Opportunities to Update the Model of Tank Closure Grout Aging (SRNL-STI-2012-00404) Based on Experimental Results by the Savannah River Ecology Laboratory

Miles E. Denham

November 2020

Figure 3: Alkali metal concentrations in effluent of column experiments of Seaman et al. (2020); each tick mark represents 100 ml of effluent.

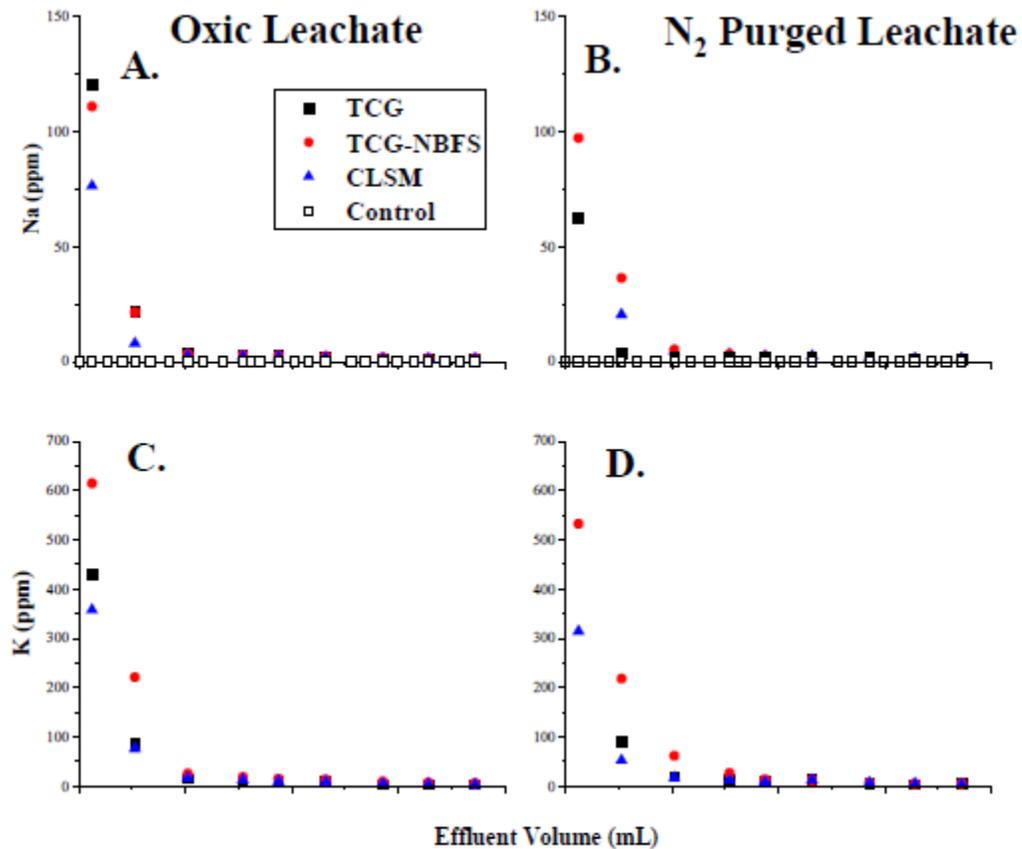
The pore fluids at the start of the 2012 model simulation of pore fluid evolution had much lower concentrations of alkali metals and a lower pH than occurs in freshly cured cement. High concentrations of alkali metals raise the ionic strength making calculation of activity coefficients less reliable. Hence, it was assumed that the alkali metals would flush out in the first pore volume of infiltration. The implied assumption is that there are no solid phases in the tank grout that release significant concentrations of alkali metals as they dissolve. This assumption is supported by the experimental results of Seaman et al. (2020). **Figure 3** (following page) shows the sodium and potassium concentrations in column experiments from Seaman et al. (2020). The concentrations are high at the start of the experiments and

decrease to very low concentrations early in the experiment, as the first 100 ml of effluent had been collected. Similar behavior is observed in the enhanced leaching batch experiments. This indicates that most of the mass of leachable alkali metals are in the initial pore water of the tank closure grout and will be flushed from the system by the first few pore volumes of infiltrate.

Figure 4: Evolution of pH during batch experiments reported in Seaman et al. (2020).

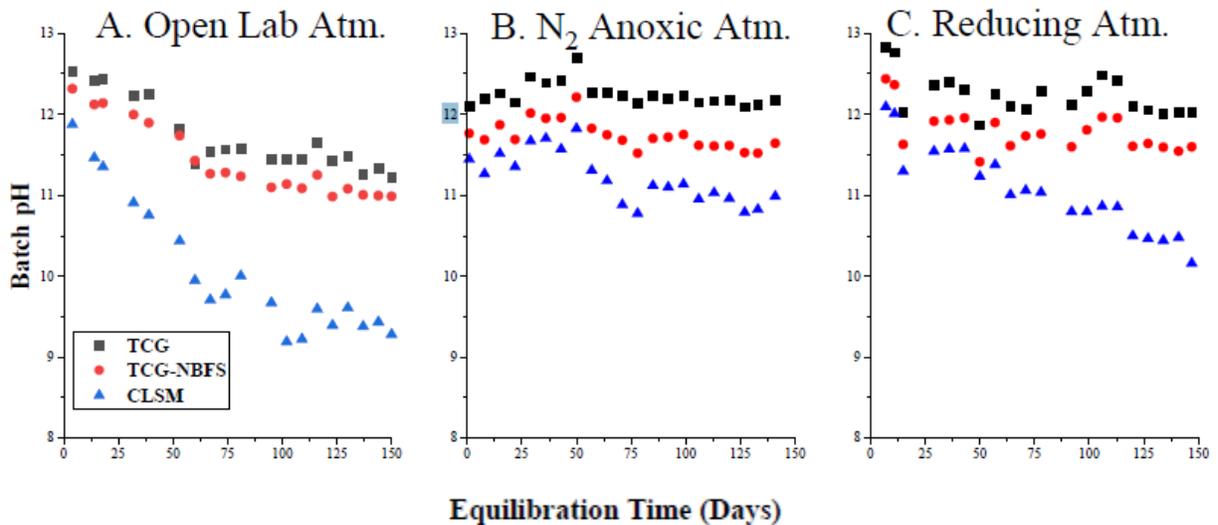
Comparison of pH evolution predicted by the 2012 model to the experiments of Seaman et al. (2020) is important because pH in tank closure grout pore fluids is critical to calculating radionuclide solubilities in water passing through the residual waste layer. In the 2012 model, the initial pH value was 11.6 and decreased to 11.1 in the first 67 pore volumes of infiltrate (Figure 2, page 4), where it remained for the duration of Reduced Region II and Oxidized Region II – across 2098 pore volumes. Evolution of pH in the batch experiments of Seaman et al. (2020) varies depending on the atmosphere in which the experiments were conducted (Figure 4, following page). Experiments open to air follow a pattern similar to the pH evolution predicted by the 2012 model. The initial pH is higher at 12.5, but pH decreases to

approximately 11.3 (11.1 for samples with no blast furnace slag) over the course of 150 days. The higher initial pH value reflects the presence of alkali metal hydroxides in solution, compared to the absence of alkali metals in the 2012 model. Values of pH evolve differently in experiments conducted under the two more reducing atmospheres. Under the nitrogen atmosphere, pH is initially approximately 12.1 and varies little over the course of the 150-day experiment. The initial pH under the Coy Chamber atmosphere is approximately 12.8, decreasing to 12.1 in the first 70 days and remaining relatively constant. Under all atmospheres the samples without blast furnace slag had pH values that were between about 0.3 to 0.6 pH units lower than samples with blast furnace slag.

The final measured pH of the experiment exposed to air is similar to the calculated equilibrium pH throughout most of Region II in the 2012 model, yet this may be coincidental. The 2012 model is best represented by the Seaman et al. (2020) batch experiment done under a nitrogen atmosphere. The 2012 model assumes that the grout was not exposed to the atmosphere while reacting. Therefore, the only CO_2 and O_2 that could react was from dissolved gases in the infiltrate. The experiment by Seaman et al. (2020) that was open to the atmosphere allowed continual reaction with atmospheric CO_2 . This resulted, as Seaman et al. (2020) note, in carbonation of C-S-H phases and precipitation of calcite. If carbonation of C-S-H was slower than dissolution of atmospheric CO_2 , then the pH would have decreased by the reaction:

Figure 5: Effect of dissolving CO₂ gas on pH of cementitious pore fluids; calculated with The Geochemist's Workbench®.

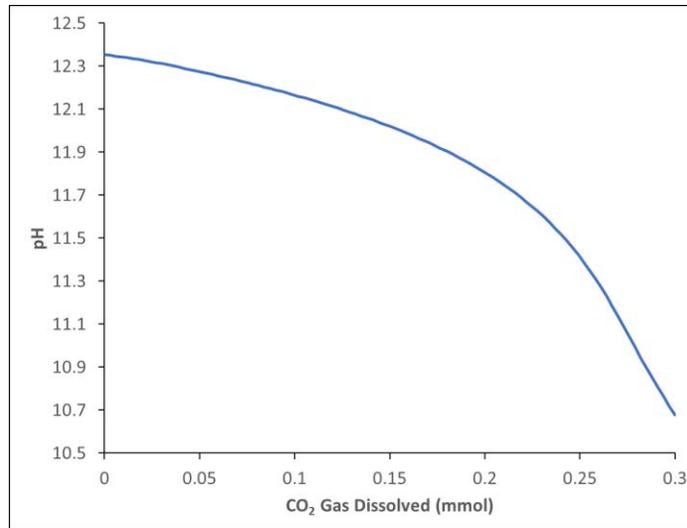
Figure 5 shows the calculated effect of dissolving CO₂ gas in 20 grams of solution with an initial composition that is similar to the solution at the start of experiment open to the atmosphere. The initial pH is 12.35 and the calcium concentration is 37.5 ppm. As CO₂ dissolves, the pH decreases. This is likely the primary reaction driving decrease of pH in the experiment, rather than reaction with cementitious phases. This is supported by the absence of a significant pH decrease in the experiments with no CO₂ in their atmospheres. In the 2012 model the concentration of dissolved CO₂ is not high enough to significantly affect pH. The pH decrease in the model was driven by reaction with cementitious phases, as well as by the influx of dissolved silica. The silica in the model infiltrate was predominantly in the species H₄SiO₄, that produced acid by deprotonation to the species H₃SiO₄⁻. There is further deprotonation in the model as H₃SiO₄⁻ reacts with Ca⁺² to form the aqueous complex CaH₂SiO₄⁰. Thus, silica in the modeled infiltrate does make some difference in the modeled pore fluid evolution.

Figure 6: Effluent pH vs. effluent volume in column experiments of Seaman et al. (2020).

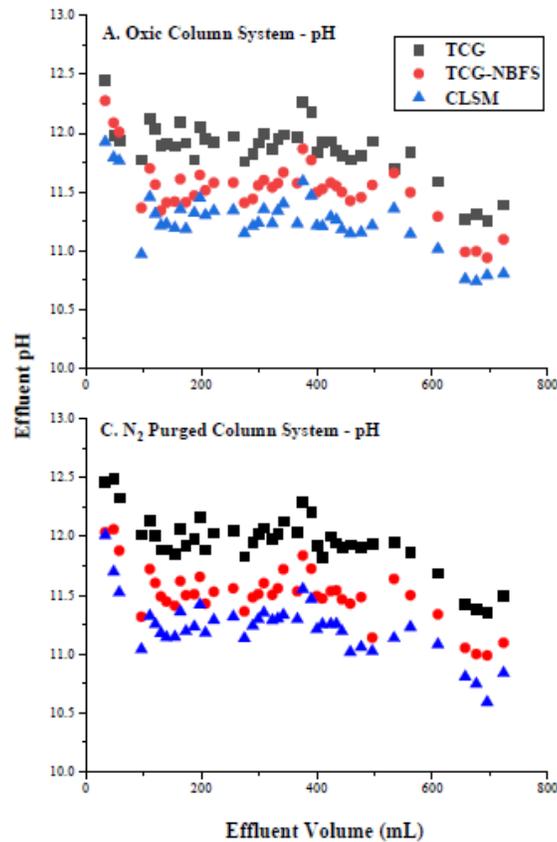
The pH decreases in the column studies reported in Seaman et al. (2020) are more likely to represent actual reaction of cementitious materials. In these experiments, only the infiltrate was open to air or purged with nitrogen. CO₂ gas from the atmosphere could not continuously dissolve in pore fluids within the column contents. Hence, the pH curves are nearly identical for the two experiments (**Figure 6**, following page). The pH values are initially approximately 12.5 because of the presence of dissolved alkali metal hydroxides and decrease as these are flushed from the column. The final pH values, after >700 ml of effluent, approach those calculated for Region II in the 2012 model – pH=11.1.

Figure 7: Eh values (mV) vs. time in batch experiments of Seaman et al. (2020).

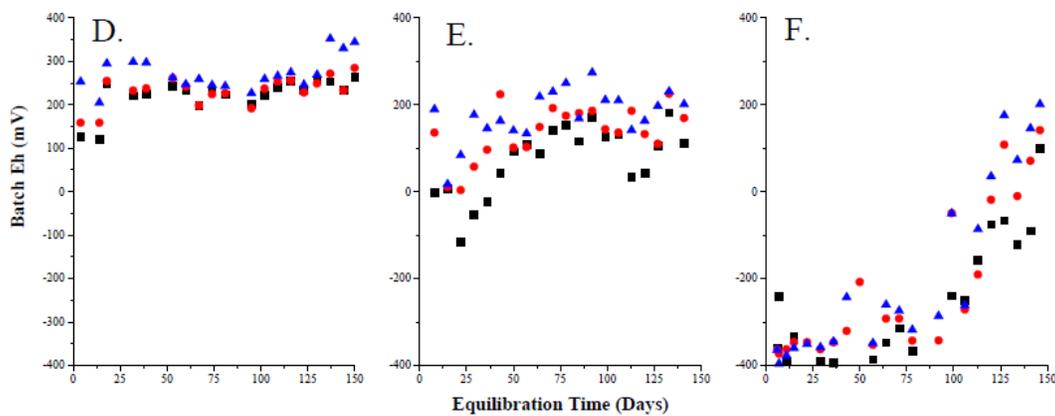
In the batch experiments reported in Seaman et al. (2020), Eh values were never as reducing as calculated in the 2012 model (**Figure 7**, following page). The lowest Eh in the experiment under a nitrogen atmosphere was approximately -120 mV, while the lowest Eh in the highly reducing

atmosphere of the Coy Chamber was -420 mV. Again, the experiments in the nitrogen atmosphere were the closest analogues to conditions assumed in the 2012 model. Eh values measured in the experiment open to the air were never below zero mV, the lowest being $+120$ mV. Eh values were generally lower in grout samples containing blast furnace slag in the experiments under a nitrogen atmosphere. This was not the case for experiments in the other two atmospheres, suggesting the atmospheres had more control on the Eh than reactions of the fluids with cementitious materials. This was noted in Seaman et al. (2020) for the Coy Chamber results. However, the Coy Chamber results present another interesting behavior: an increase in Eh with time. This was also the behavior in the experiments under nitrogen, but it can be argued that in these experiments the initial low Eh values were caused by reaction with small high surface area particles containing reduced iron or sulfur. Once these particles were oxidized the Eh increased. The highly reducing atmosphere of the Coy Chamber should have constrained Eh to highly reducing values if it was solely the atmosphere controlling the Eh.

Figure 8: Eh vs. effluent volume in column studies of Seaman et al. (2020).

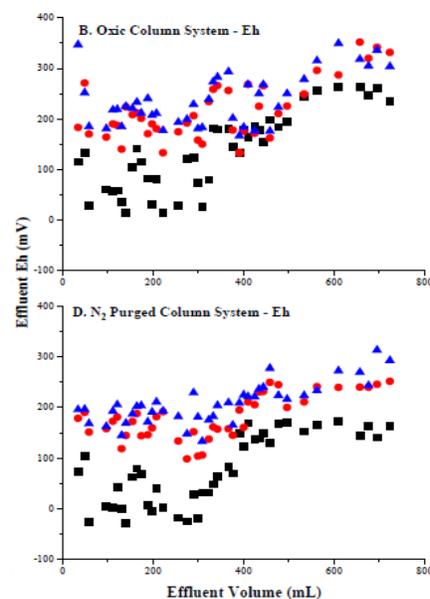
Eh values in the column experiments start near zero mV and increase with volume of effluent passed through the column (**Figure 8**, previous page). The atmosphere to which the infiltrate was exposed made little difference to the Eh values or their evolution and samples containing blast furnace slag had consistently lower Eh values than those without slag. These observations suggest that the Eh values in the column experiments were controlled by reaction with the cementitious materials.

It is recommended that consideration be given to the nature of Eh measurements versus modeled values and the possibility of using both in Performance Assessments. The 2012 model produces extremes at the oxidizing and reducing conditions. In the oxidizing regions, the 2012 model is constrained by equilibrium with dissolved oxygen. In the reducing region, Eh is controlled by selection of a mineral phase containing reduced species (e.g., pyrite). Measurement of Eh values in experiments of both Seaman et al. (2020) and Walter and Dinwiddie (2020) fall between these extremes. Yet, the meaning of measured Eh values is uncertain because of redox disequilibrium (Bethke, 2008). Thus, careful consideration must be given as to how Eh values are selected when calculating radionuclide solubilities. Appendix 2 discusses this in more detail.
